1R - 433

**From:** Price, Wayne  
**Sent:** Friday, March 11, 2005 8:54 AM  
**To:** 'Mike Griffin'; Price, Wayne  
**Cc:** chris.biagi@dvn.com; Sheeley, Paul  
**Subject:** RE: Devon Patsy Site 1R0433

Attached, please find a photo of our excavation at the Devon Patsy Site southeast of Monument. As you may recall the site has three distinct point sources. The first is a spread zone situated immediately south of a pit. The contamination within this area is rather topical extending to a maximum depth of 8' below ground surface.

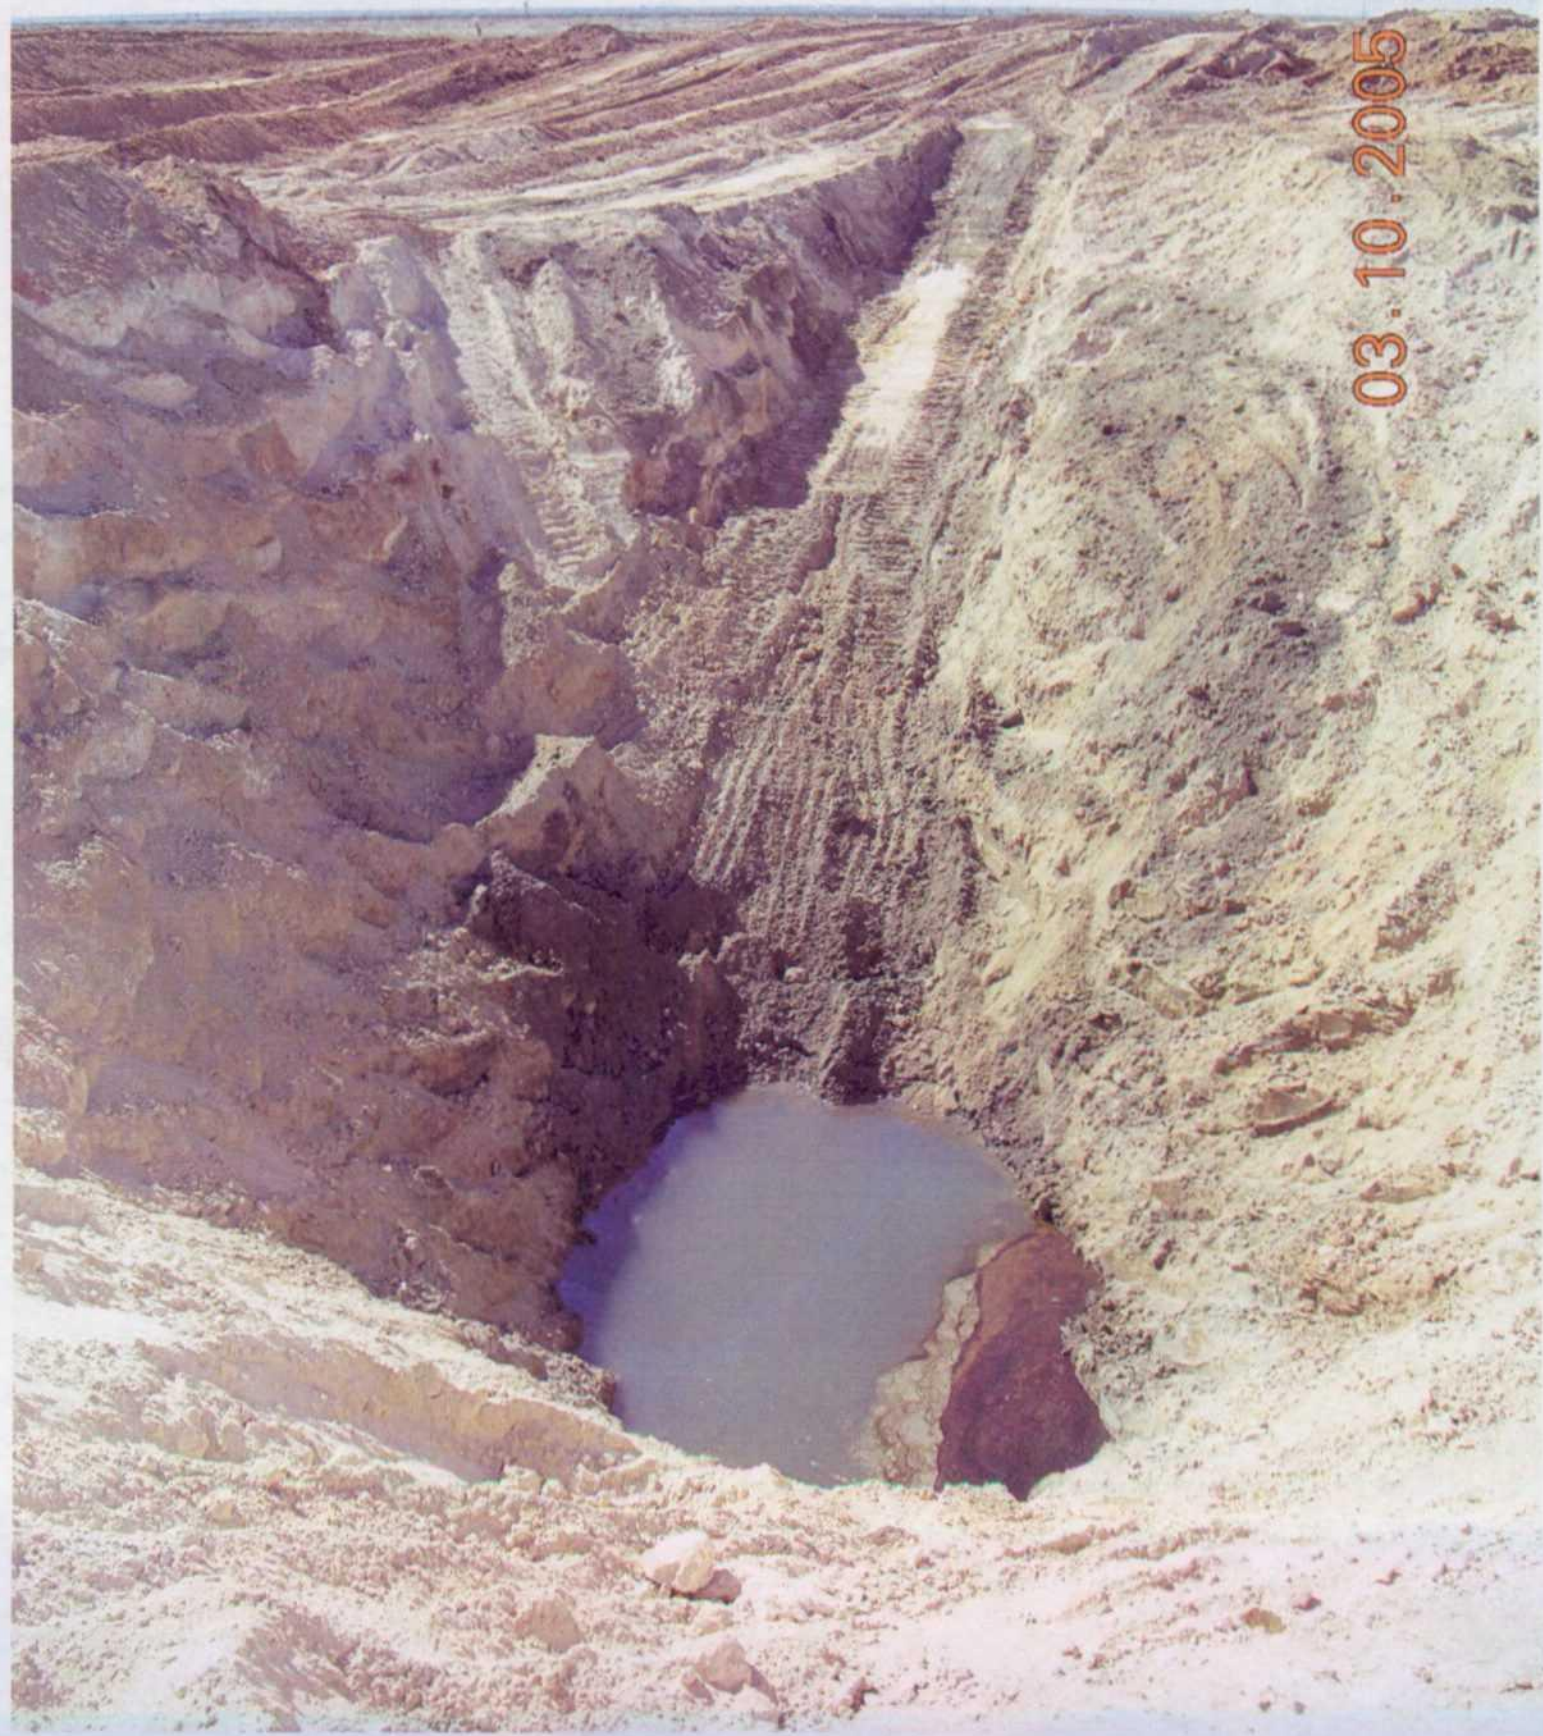
The third area is the pit, itself. We initially excavated the pit to a depth just above the table (located at 32' bgs) and found TPH concentrations to be over 7,000 ppm consisting largely of aromatic fractions. We then excavated below the groundwater surface to a total depth of approximately 38' bgs and allowed the hole to fill with water. As you will see from the attached photo, the free product consists of less than 1% of the total fluid volume.

We would like to take a trash pump and send this water to our mix pile where it will be subsequently mixed and blended with already excavated soils to a maximum concentration of <500 ppm. Though we would prefer to simply pump out the water and send it to commercial disposal, it would require us to spend at least two days constructing a ramp for the water truck to reach a depth where the vacuum pressure within the truck exceeds the hydrostatic weight of the fluid column we hope to remove, (maximum 15').

Our trash pump will move several hundred gallons per hour and we will berm the discharge end of the hose to insure that it doesn't simply run off onto the surface. We will continue to pump this water until we no longer have any floating product atop the table.

OCD has a Rule 13 (General Operations/Waste Prohibited) and Rule 710 concerning this matter. Prohibit wasting oil and placing produced water onto the surface of the ground. There are exceptions and this is in a grey area, but OCD would like to see any oil and oil water recovered to be recycled. Therefore your request is hereby denied.

OCD recommends that you use your trash pump to pump the water and oily emulsions up to a small staging tank where the vacuum truck can haul it to a proper disposal.

If you choose this method then please maintain all disposal records. After the water meets WQCC standards or when all practical free product has been removed then Devon may submit a request for closure with a monitoring plan if necessary. The excavated hole shall not be filled back in until OCD approves. Devon may continue performing any necessary remedial actions for safety and environmental reasons.
